## SERVICE INFORMATION LETTER NO. SIL20A1-008

All DA20-A1 aircraft.

The improvement in the design of the Nose Landing Gear (NLG) Fork assembly. The old P/N 20-3220-08-00 has been replaced with the new NLG Fork assembly, P/N 20-3220-08-00\_1.

Figure 1

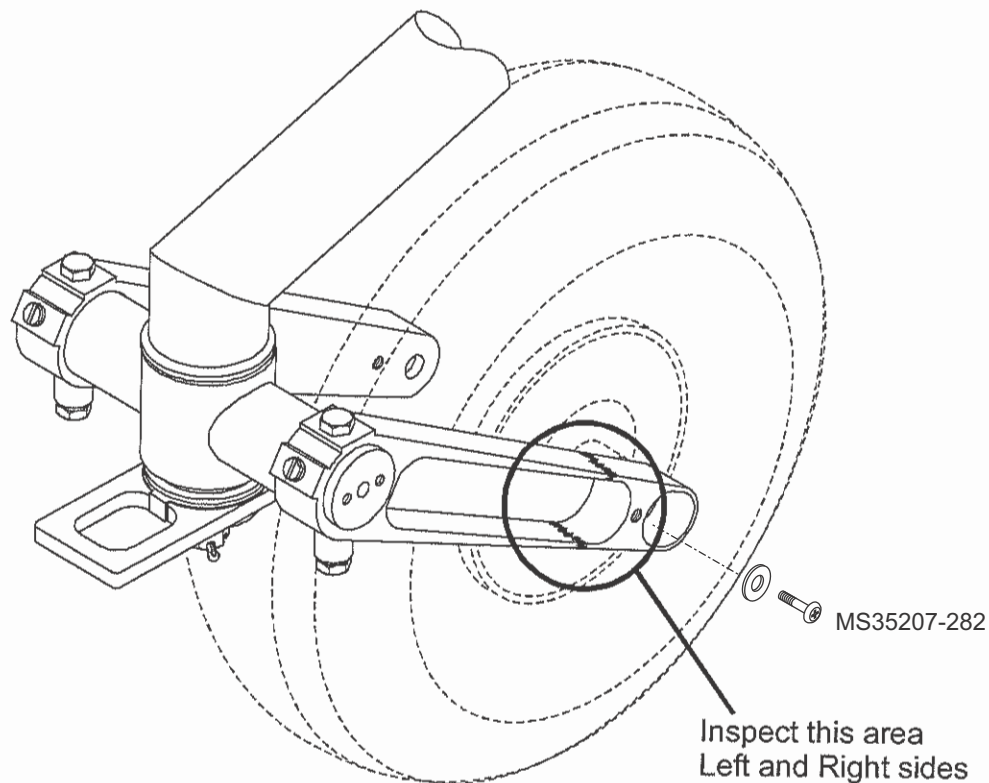
Cracks have been found on some NLG Fork assembly, P/N 20-3220-08-00 during routine inspections. Cracking usually occurs on higher time aircraft but could occur sooner with rough field operations or hard landings. Figure 1 shows where the cracking has normally occurred. Also, the machine screw, pan head, P/N MS35207-282 (see Figure 1) should be installed with Loctite 242 when the wheel fairings are not used to avoid any potential cracking that may occur at that location.
